MONTGOMERY COUNTY PLANNING DEPARTMENT
THE MARYLAND-NATIONAL CAPITAL PARK AND PLANNING COMMISSION

REVIEW TYPE: Preliminary Plan of Subdivision

APPLYING FOR: Two lots for two one-family detached dwelling units

PROJECT NAME: Jackson's Acres
CASE #: 120070530
REVIEW BASIS: Chapter 50, Montgomery County Subdivision Regulations

PRELIMINARY PLAN
JACKSONS ACRES
 (Parcel 444 / Tax Map KR11; Liber/19472 Folio/688)
Montgomery County, Maryland

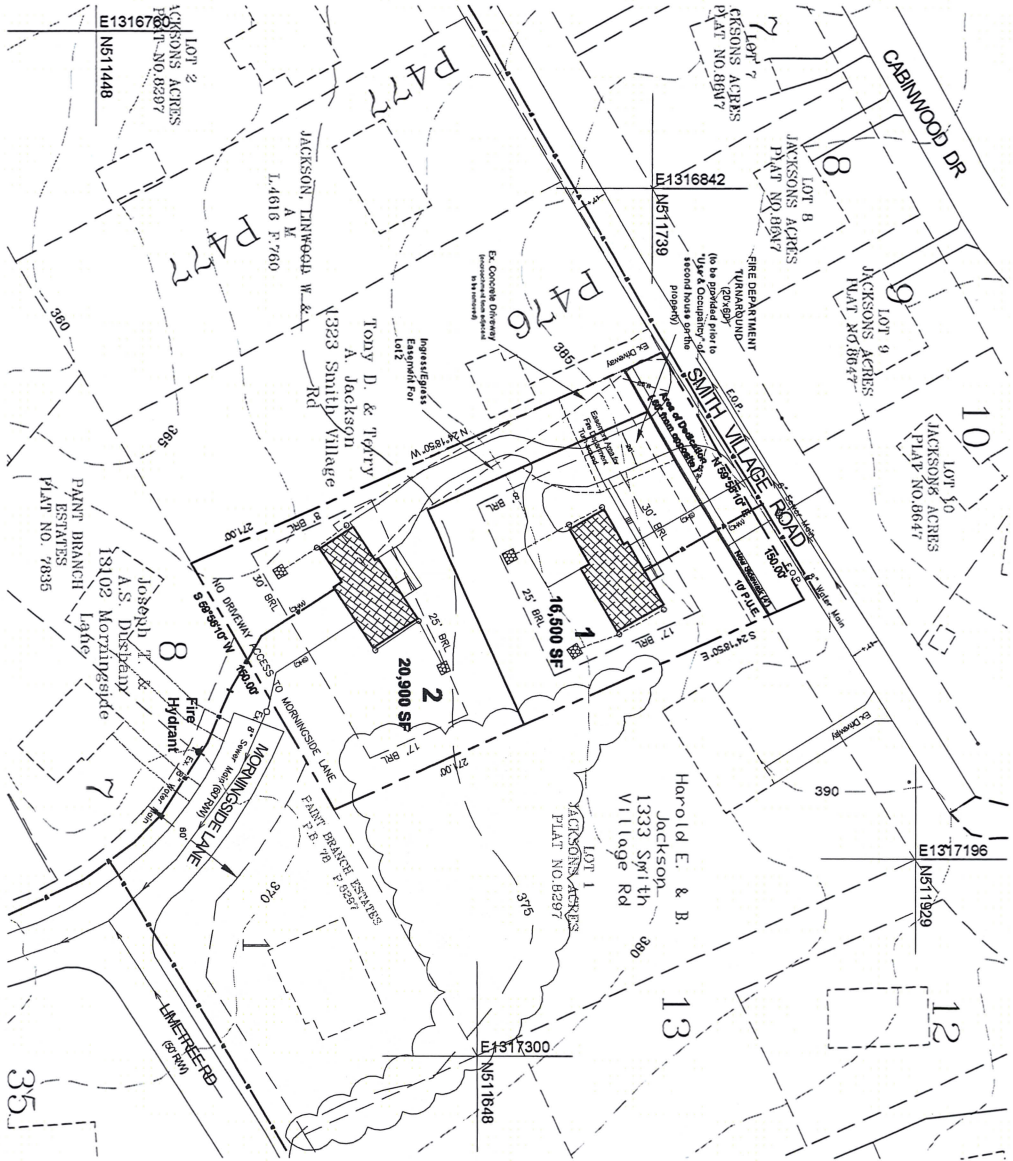
We have completed our review of the preliminary plan revised on 05/07/08. This plan was reviewed by the Development Review Committee at its meeting on March 5, 2007. We recommend approval of the plan subject to the following comments:

1. Right of way dedication for Smith Village Road and Morningside Lane as necessary.
2. Grant necessary slope and drainage easements. Slope easements are to be determined by study or set at the building restriction line.

3. A Public Improvements Easement may be necessary along Smith Village Road, in order to accommodate the required sidewalk construction. Prior to submission of the record plat, the applicant's consultant will need to determine if there is sufficient right of way to permit this sidewalk construction. If not, the applicant will need to either dedicate additional right of way or execute a Declaration of Public Improvements Easement document. That document is to be recorded in the Land Records of Montgomery County, with the liber and folio referenced on the record plat.

5. Record plat to reflect a reciprocal ingress, egress, and public utilities easement to serve the lots accessed by each common driveway.
6. Record plat to reflect denial of access along Morningside Lane.

8. In accordance with Section 49-35(e) of the Montgomery County Code, sidewalks are required to serve the proposed subdivision. Sidewalks are to be provided along the site frontage on Smith Village Road according to associated DOT standard street section unless the applicant is able to obtain a waiver from the appropriate government agency.
